Re: Benefit-Cost Analysis of the Proposed Energy Efficiency Utility Programs Associated with the New Jersey Economic Stimulus Plan (CEEEP Draft Report dated December 15, 2009)

Comments of the New Jersey Department of the Public Advocate, Division of Rate Counsel, regarding

"Benefit-Cost Analysis of the Proposed Energy Efficiency Utility Programs Associated with the New Jersey Economic Stimulus Plan" (CEEEP Draft Report dated December 15, 2009)

March 3, 2010

Price of Electricity by Sector Assumed by AEO for Mid-Atlantic Region

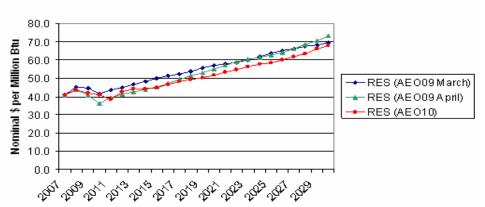
- (e) Electricity price projection: CEEEP's electricity price projection is based on the older version of the EIA's Annual Energy Outlook 2009 ("AEO 2009") (issued in March). The updated price projection in AEO 2009 April version and the results of the preliminary AEO 2010 take into account the economic crisis and the American Recovery and Reinvestment Act. They are projecting lower electricity prices than in the original AEO 2009 (See Figure below). In CEEEP's future BC analysis, we recommend CEEEP consider investigating and adopting the updated price projection in AEO 2009 April version or the price projection of AEO 2010.
